**PRELIMINARY/FINAL DRAINAGE REPORT  
FOR  
REDTAIL RANCH FILING 1**

**NOVEMBER 2018**

PCD Project No. SP-18-004/SF-18-021

**FEMA MAP**

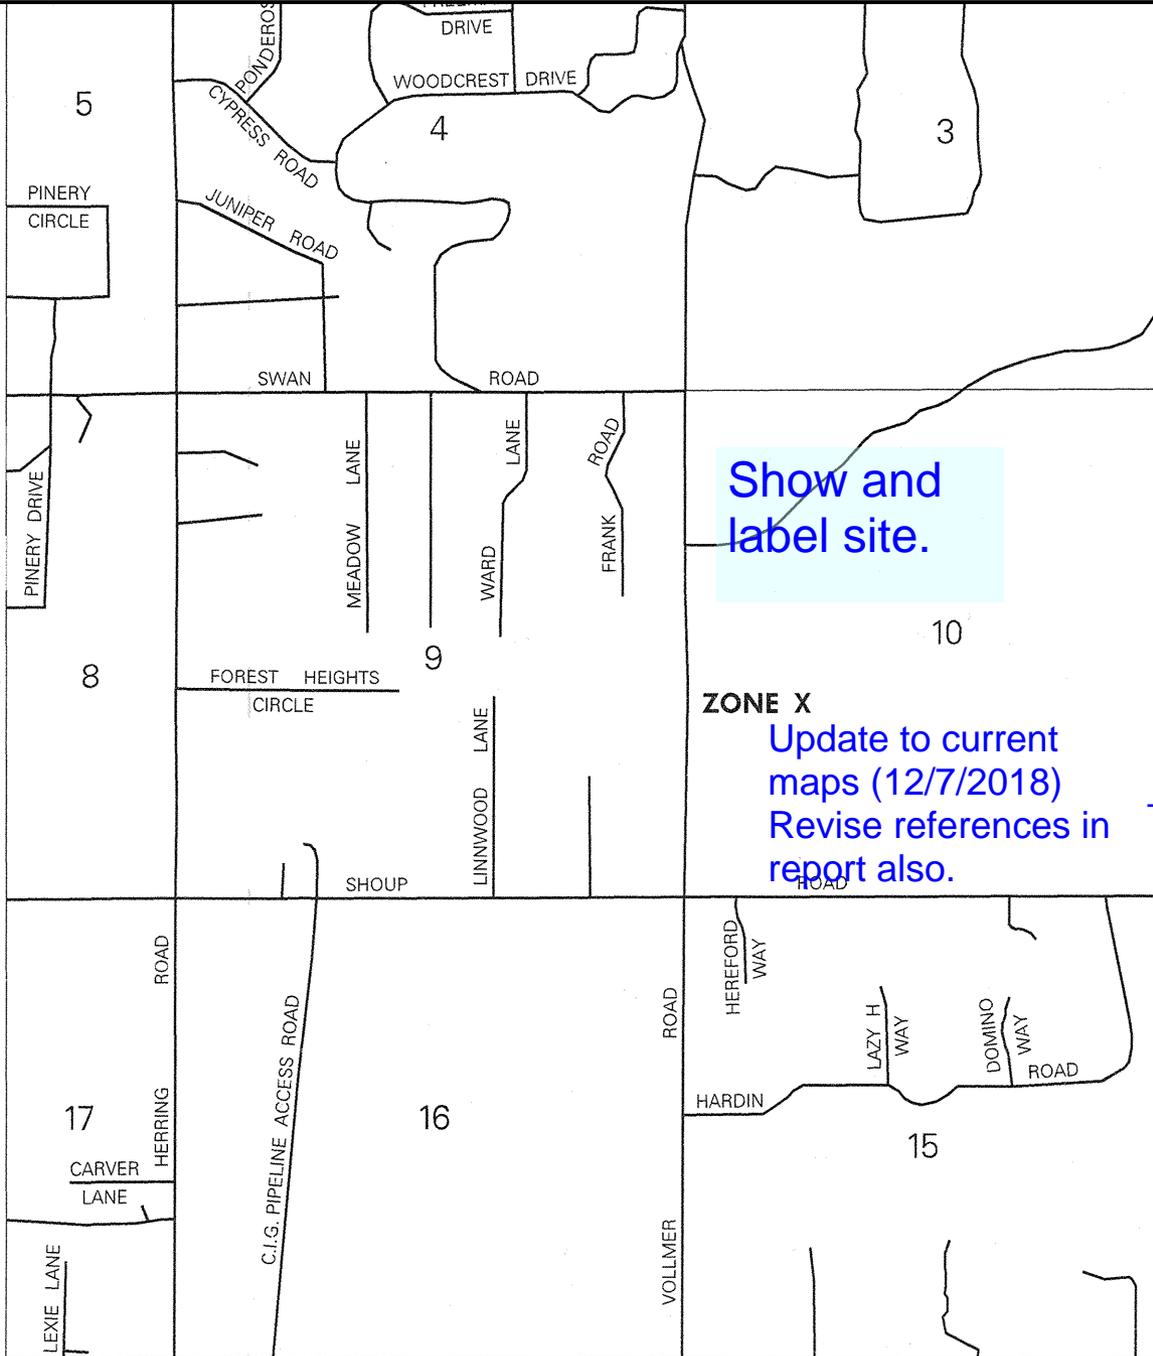
Show and label site.

**ZONE X**  
Update to current maps (12/7/2018)  
Revise references in report also.

**RETAIL RANCH**  
PRELIMINARY/FINAL DRAINAGE REPORT  
DEVELOPED DRAINAGE MAP

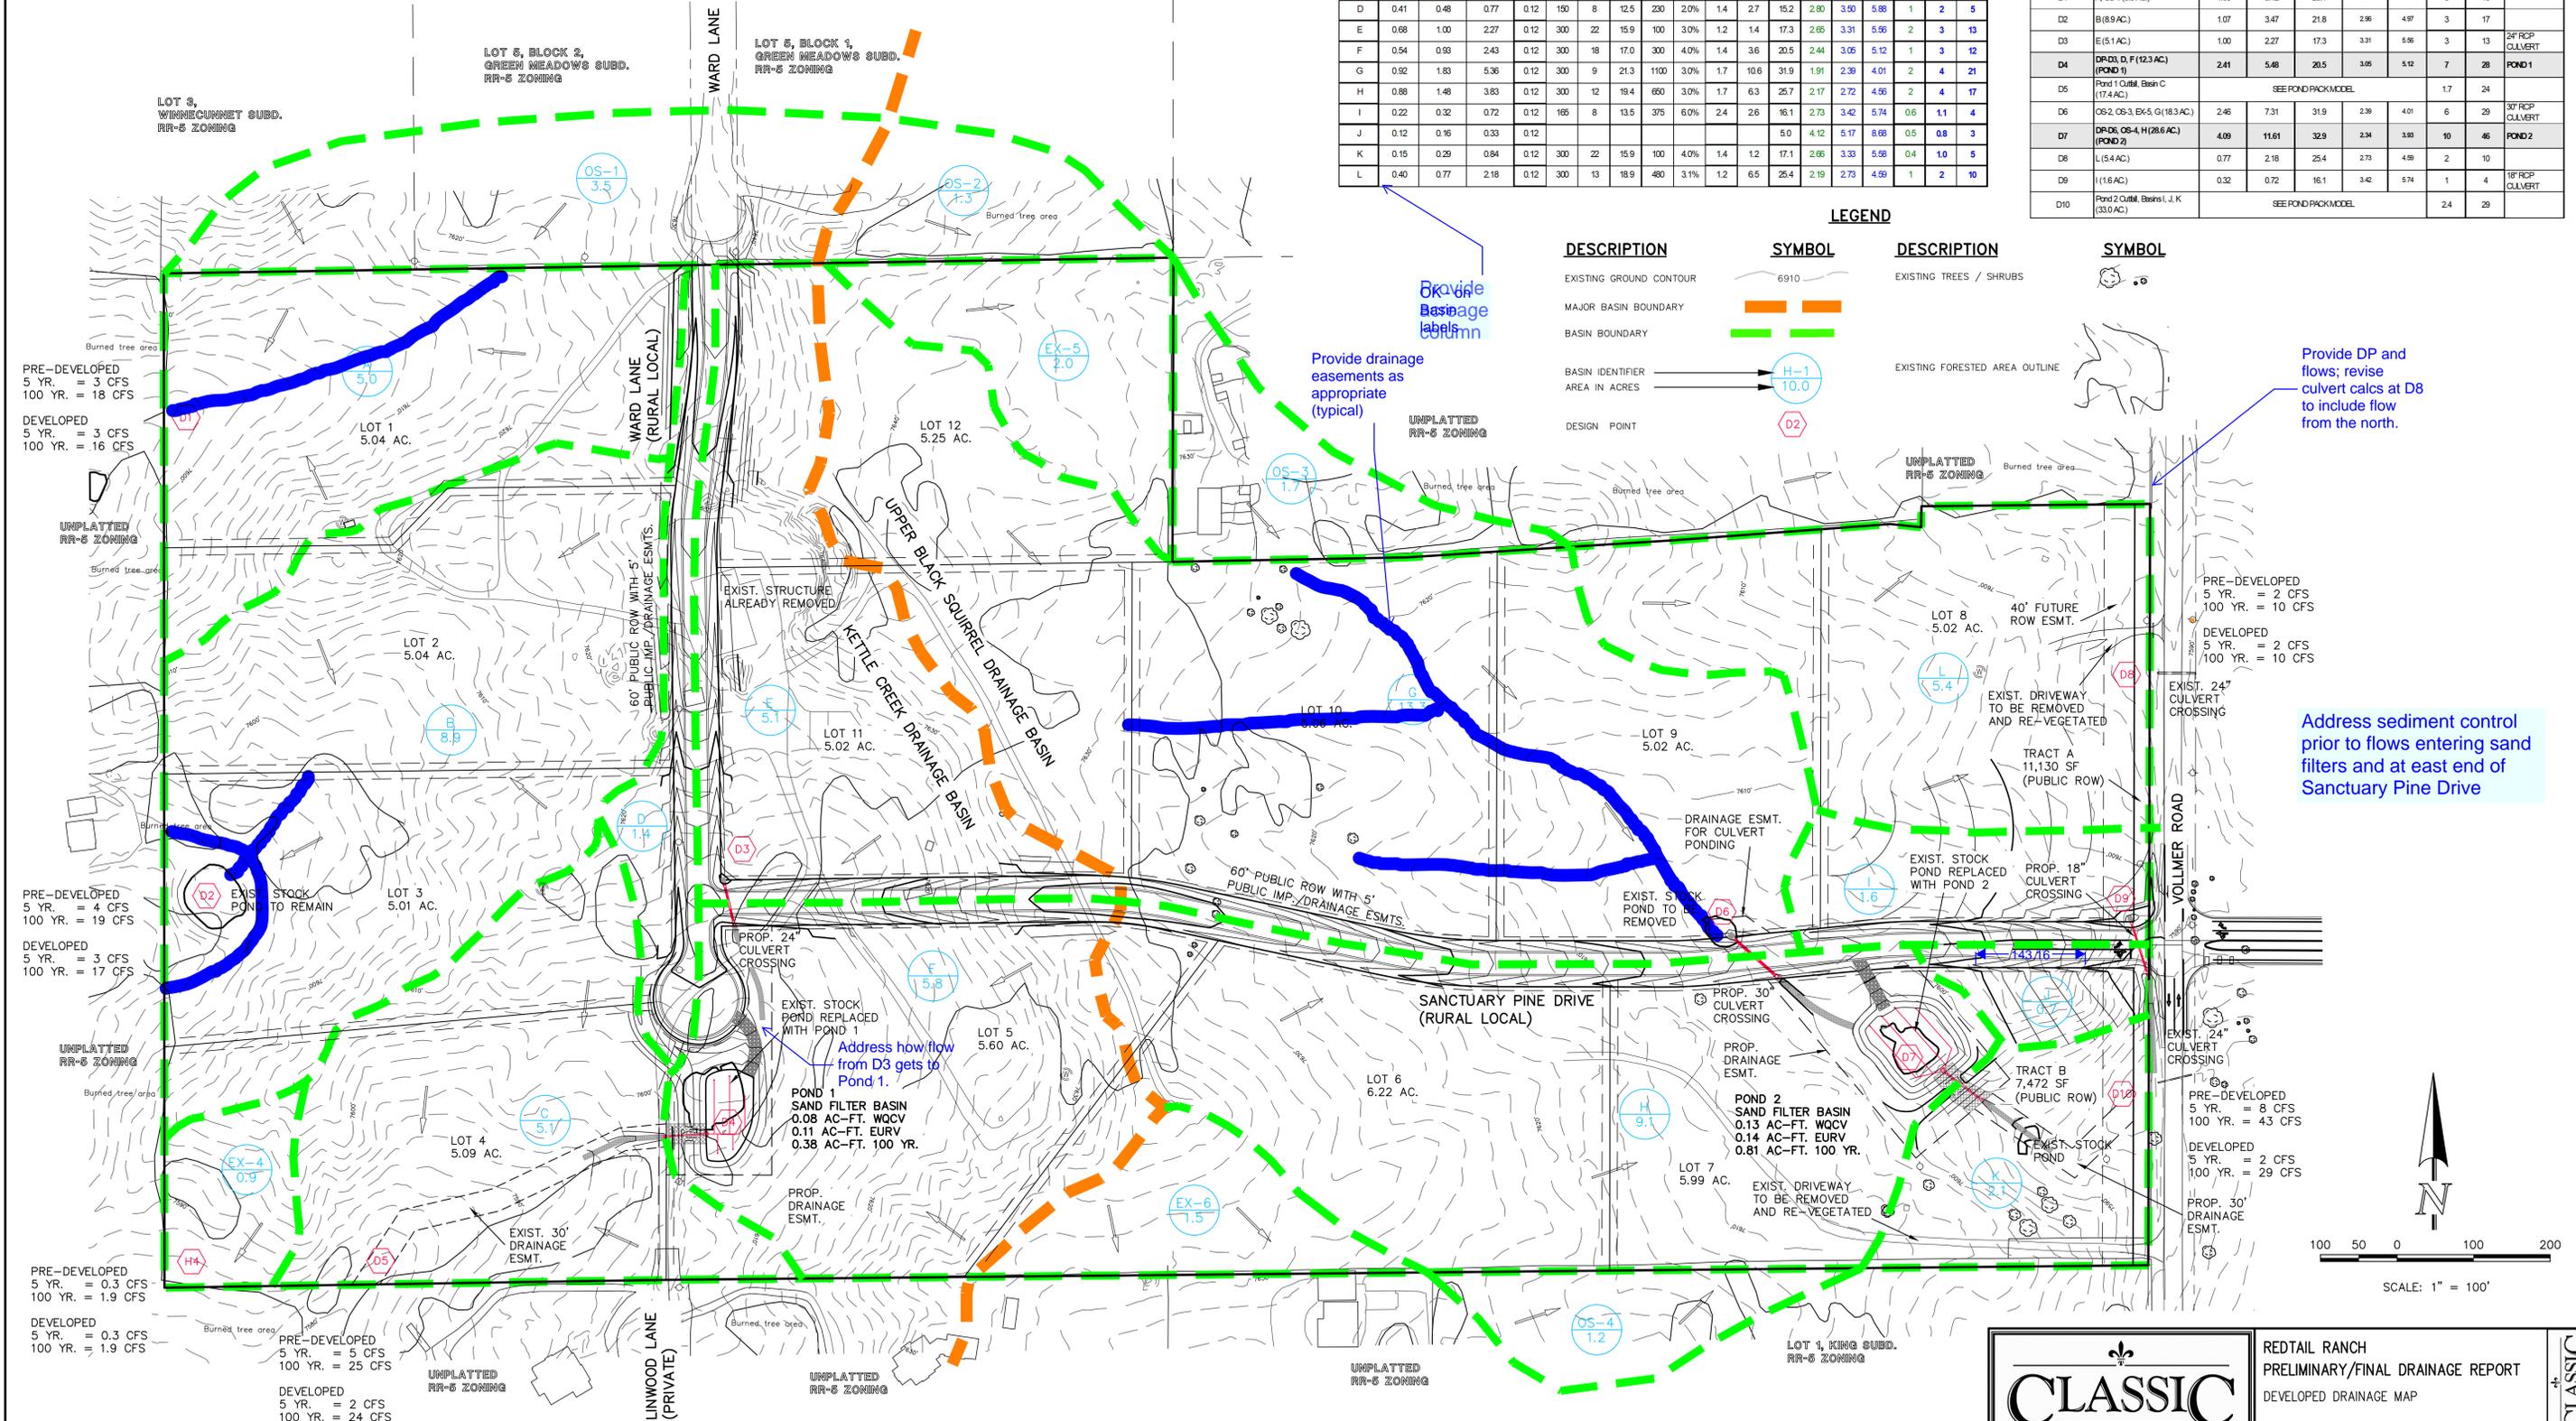
Provide DP and flows; revise culvert calcs at D8 to include flow from the north.

Provide drainage easement as appropriate

Provide drainage easements as appropriate (typical)
